**Before the Hearings Panel
At Porirua City Council**

In the matter of the Proposed Porirua District Plan

**Statement of evidence of Alistair Osborne on behalf of Porirua City Council
(Flood Hazard Modelling)**

Date: 10 February 2023

Figure 3 Proposed drainage solution at 300c Paremata Rd (source: 300c Paremata Road existing drainage improvements)

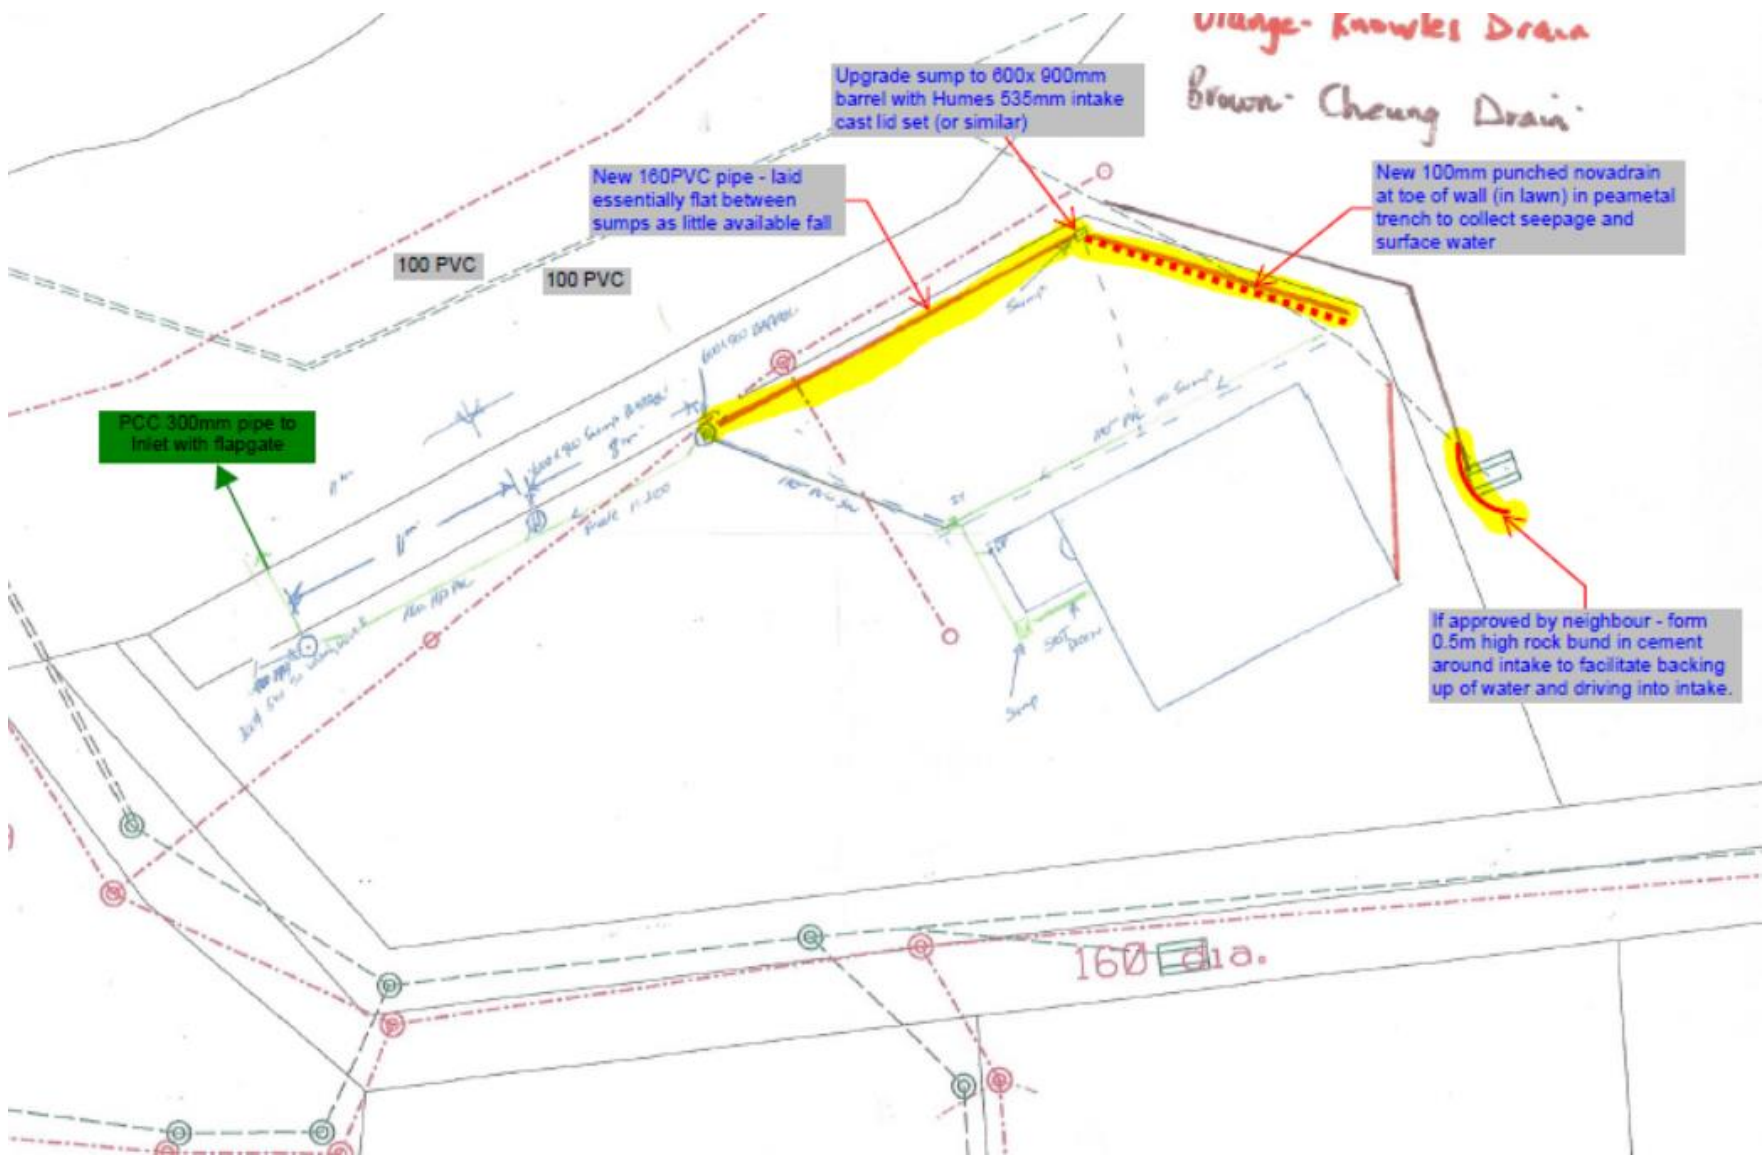
- 19 It is considered that this has eliminated any flood hazard and risks as is evident with on the ground conditions.
- 20 A review of the as-built plan covering the works described by the submitter along with the investigation¹ upon which the works were based has shown that the stormwater assets installed at the property extend along the boundary between 300c Paremata Rd and 300b Paremata Rd (refer to Figure 3 below).

- 21 The as-built plan shows the pipes installed were no larger than 160mm in diameter.
- 22 The investigation upon which the works were based notes that ponding will occur on the property if the PCC drain, into which the new pipes are connected, is at capacity (full), or if the Inlet (Pauatahanui Inlet) restricts flow. The investigation reports that sea level rise will restrict the ability of the system to drain the property.

- 23 With consideration of these points, I disagree that the flood mapping ponding overlay is in error for the reasons outlined below.
- 24 A review of the model and the WWL GIS asset data shows that network upgrades done in 2019 was not available at the time of the stormwater model build and has not been included in the model or the current GIS asset data. However, I am confident that this will not affect the flood hazard mapping layers in this area.

Figure 4 Modelled stormwater overflows at 18 The Layline

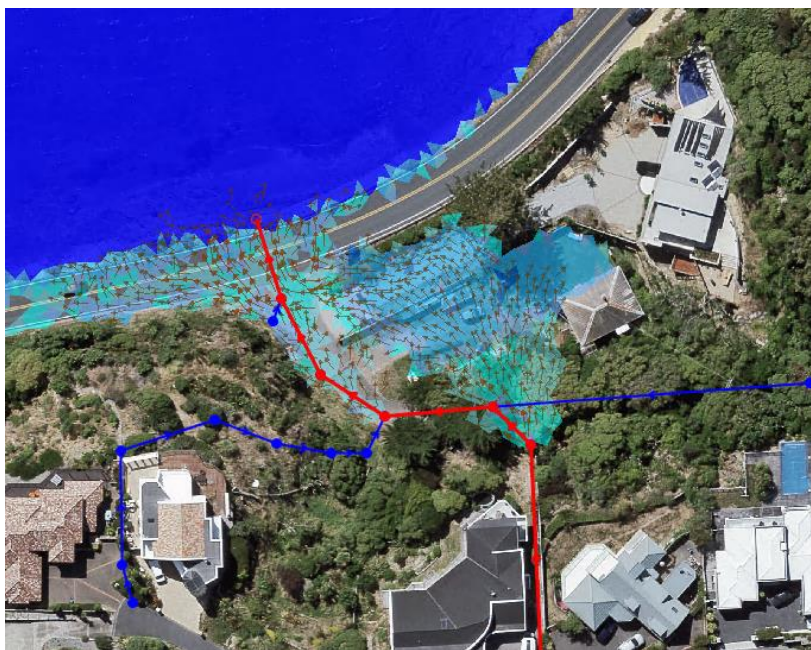
- 26 The modelled flooding that extends onto 300c Paremata Road is based on an extreme storm event, the 100-year ARI (with climate change, including sea level rise) event, and is a result of the stormwater network surcharging upstream of the property in 18 The Layline (refer to Figure 4 below).

27 The nature of this flooding (originating south of the property) shows that the installed network described by the submitter, extending along the western and northern boundary of the site, would not capture or alleviate the flooding generated from the surcharging network shown in the image above.

28 The lack of inclusion of a non-return gate in the model is unlikely to have an impact on the resultant flooding as our modelled scenario includes a high tide with 1m of sea-level rise. This will impede outflow from the network, as is noted by the investigation report described above, and would do so with or without a non-return gate in place.

Figure 6 Proposed flood hazard mapping for the Northern Growth Area

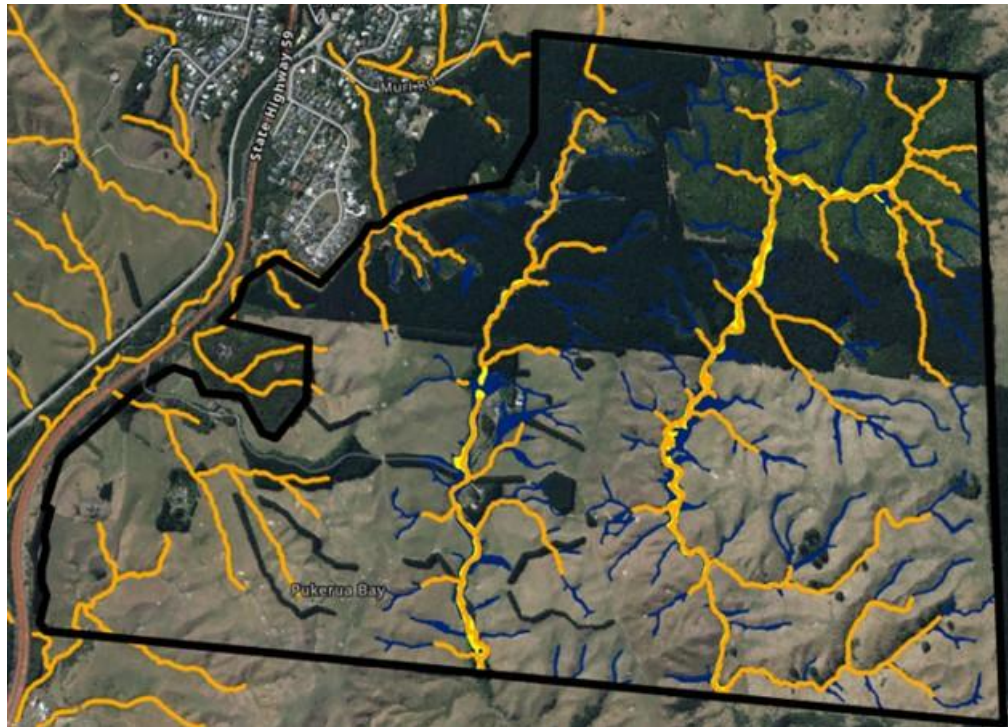
32 Submission OS 74.73 by Greater Wellington Regional Council reports that current the PDP does not include ponding zones and overland flow paths in the Northern Growth Area. Their position is that areas covered by these flood hazard components will be subject to flooding so these components should be shown in the PDP. This is to ensure the PDP has regard to the Proposed RPS Change 1 Policy 29.

33 This is correct and suitable modelling will be undertaken to enable the development of ponding zones and overland flow paths for the Northern Growth Areas for inclusion in the PDP.

Figure 7 Elevation at 42 Gray St

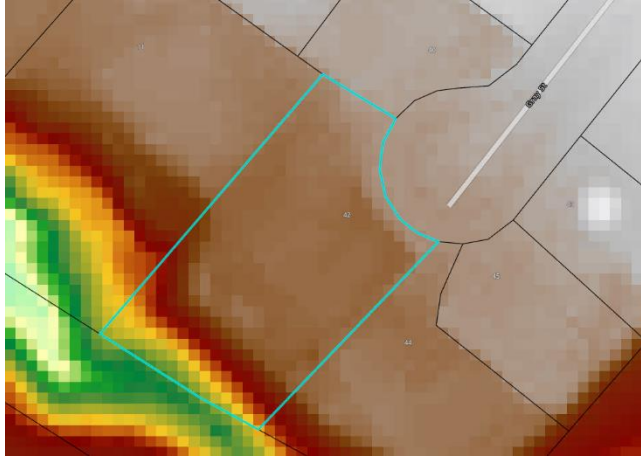
37 The first concern is that the model topography does not capture the site earthworks that took place at the time of the subdivision development, that lead to a portion of 42 Gray being filled to create a level building platform. This is not the case, and the modelled topography does capture the level building platform across 42 Gray St, above the stream gully at the rear of the property. This is shown in the Figure 7 below where the minimal variation in colour across the

Figure 8 Aerial photograph of 42 Gray St

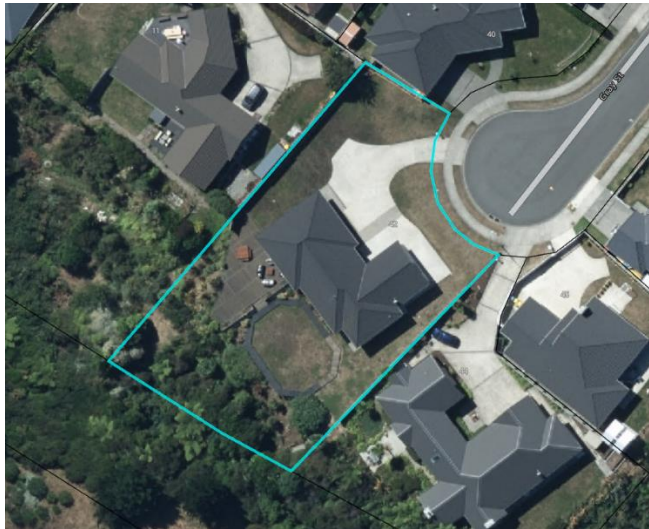
highlighted section indicates minimal variation in elevation (that is, a level surface). This matches the surface seen in the aerial photograph and Google Streetview photo of the site (refer to Figure 8 and Figure 9 below).

Figure 13 Model topography (LiDAR 2013)

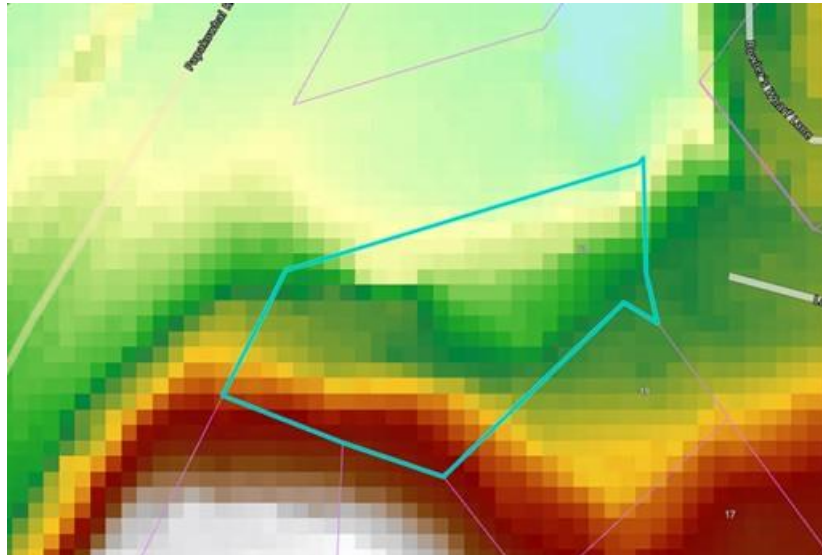
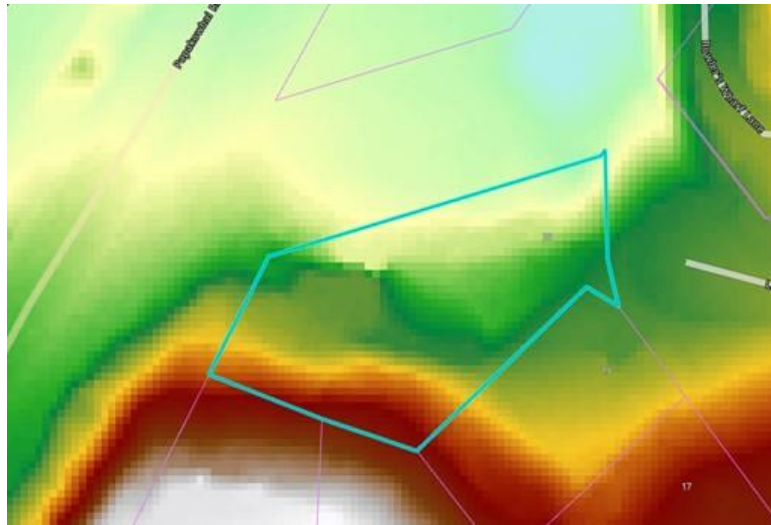
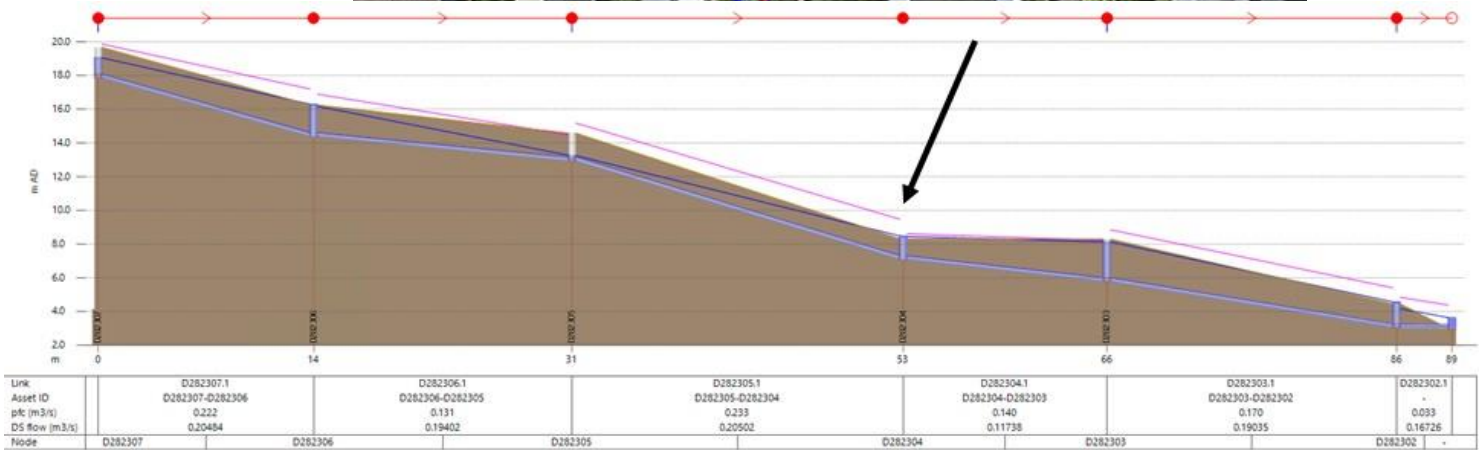
44 Submissions OS 115.1, OS115.2, and OS115.3 by D Suzi Grindell of the property 21 Langwell Place, Papakowhai, report that the flood detention designation should be removed from the area in front of 21 Langwell Place northwards to the macrocarpa trees along Papakowhai Road. D Suzi Grindell's concern relate to perceived out-of-date topographic mapping which has caused inaccuracies in the flood mapping.

- 51 With regard to the comment on the out-of-date topography, I am unaware of the of any significant changes to the topography in the area of 21 Langell Pl, that would impact the flood mapping. The three images in Figures 12 - 14 below show an aerial photograph of the area, the modelled topography based on 2013 LiDAR, and the topography data collected in 2015 (which was not available at the time of modelling). There does not appear to any significant difference between them that would indicate out-of-date information.

Figure 15 Nodes surcharging onto the front portion of 21 Langwell Pl.

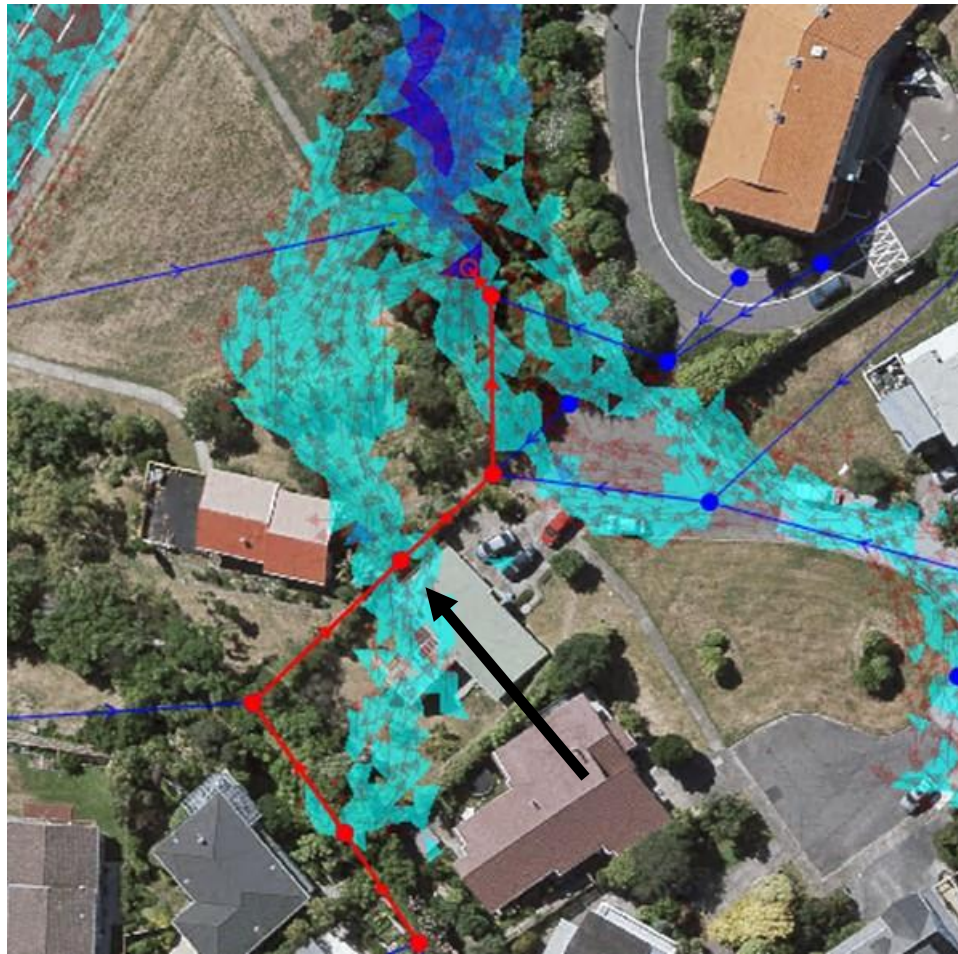
52 In relation to the D Suzi Grindell's point that the flood mapping is exaggerated at the front of the section and that it does not generally flood and the existing installed drainage system is adequate, it is noted that the mapped flooding hazards are based on modelling of an extreme event (100-year ARI) with allowance for climate change, including 1 metre of sea level rise. In this event the Wellington Water stormwater model shows that the current network does not have capacity to contain the storm runoff. The image in Figure 15 below shows a stormwater manhole on the southern side of the 21 Langwell Pl property surcharging and spilling water that flows north across 21 Langwell Pl. This is combined with overland flow originating from an upstream manhole on 6 Thurso Gr that also surcharges during the modelled event.

53 As a result, the flooding seen on 21 Langwell Pl is not due to flooding in the Langwell Pl cul-de-sac and cleaning the drain grates will not impact it – though it is encouraged. In addition to this the Wellington Water stormwater models assume a clean system with no blockages or
